Maxtor Corporation  
500 McCarthy Boulevard  
Milpitas, CA 95035 USA

To: T10 CAP Working Group  
Contact: Mark Evans  
Phone: 408-894-5310  
Email: mark\_evans@maxtor.com  
Date: 31 October 2002

Subject: SAM-3, SPC-3, and SBC-2 power conditions proposal

Figure PC – Power condition state machine

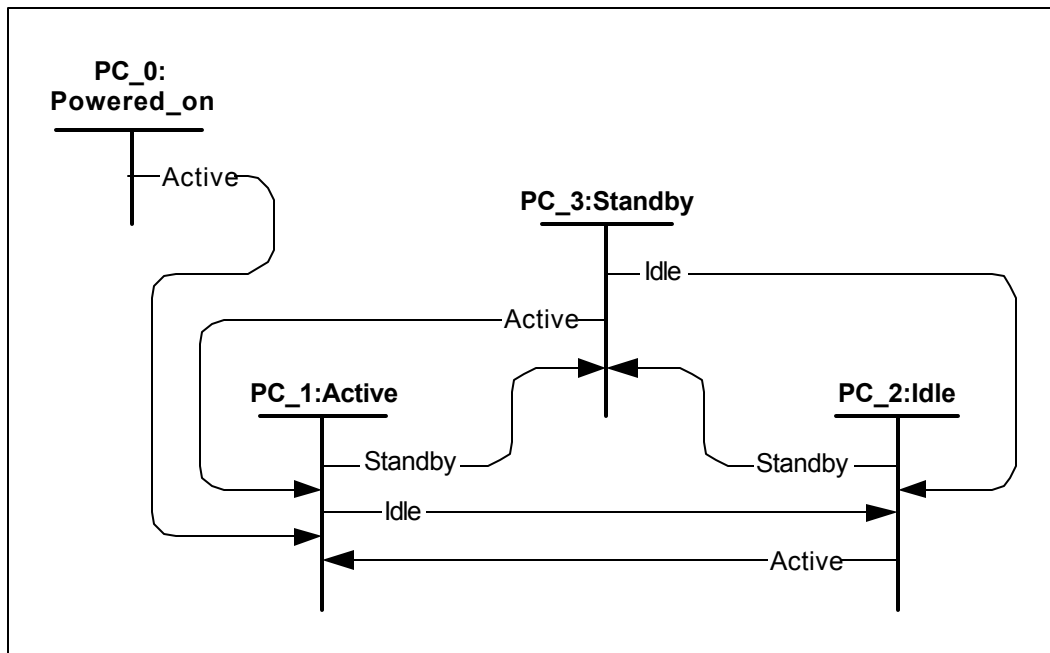
Replace subclause 8.4.11 with the following:

Figure PC describes the PC state machine.

The power condition state machine (PC) describes the logical unit power states and transitions resulting from Power Condition mode page settings.

- a) PC\_0:Powered\_on;
- b) PC\_1:Active;
- c) PC\_2:Idle; and
- d) PC\_3:Standby.

The PC state machine shall start in the PC\_0:Powered\_on state after power on.

Figure PC\_SSU – Power condition state machine for logical units implementing the START STOP UNIT command

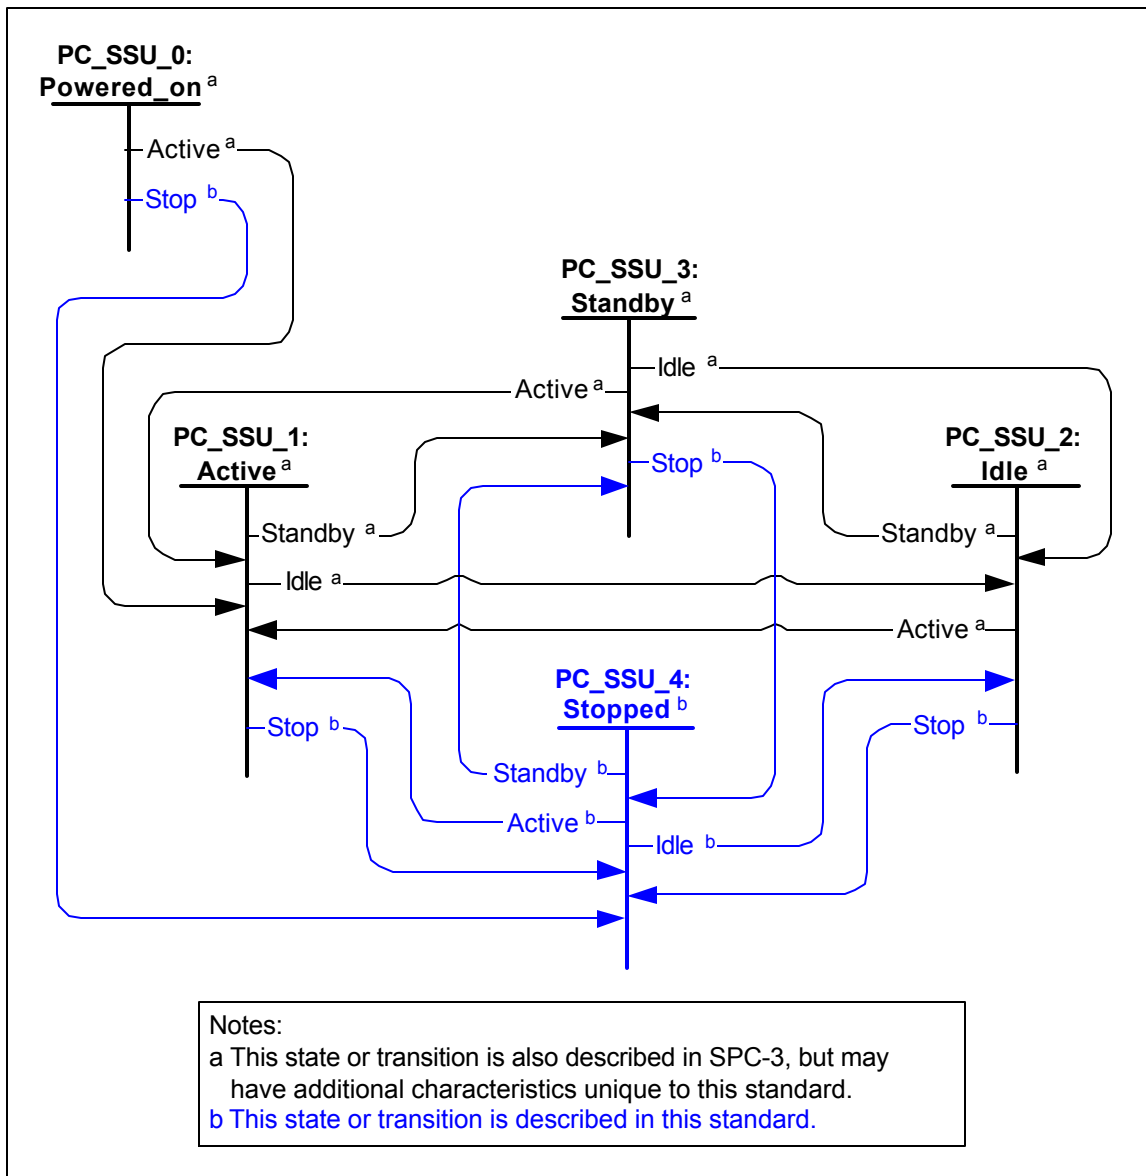
Replace subclause 5.2.24 with the following:

Figure PC\_SSU describes the PC\_SSU state machine.

The power condition state machine for logical units implementing the START STOP UNIT command (PC\_SSU) describes the logical unit power states and transitions resulting from settings by the START STOP UNIT command and settings in the Power Condition mode page (see the Power Conditions mode page subclause in SPC-3).

- a) PC\_SSU\_0:Powered\_on;
- b) PC\_SSU\_1:Active;
- c) PC\_SSU\_2:Idle;
- d) PC\_SSU\_3:Standby; and
- e) PC\_SSU\_4:Stopped.

The PC\_SSU state machine shall start in the PC\_SSU\_0:Powered\_on state after power on.

Note: The PC\_SSU state machine is an enhanced version of the Power Condition state machine described in SPC-3. The PC\_SSU\_0:Powered\_on, PC\_SSU\_1:Active, PC\_SSU\_2:Idle, and PC\_SSU\_3:Standby states and their transitions to each other described in this standard are analogous to the PC\_0:Powered\_on, PC\_1:Active, PC\_2:Idle, and PC\_3:Standby states and their transitions, respectively, as described in the Power Condition mode page subclause in SPC-3. The PC\_SSU\_4:Stopped state and its related transitions are unique for block devices.
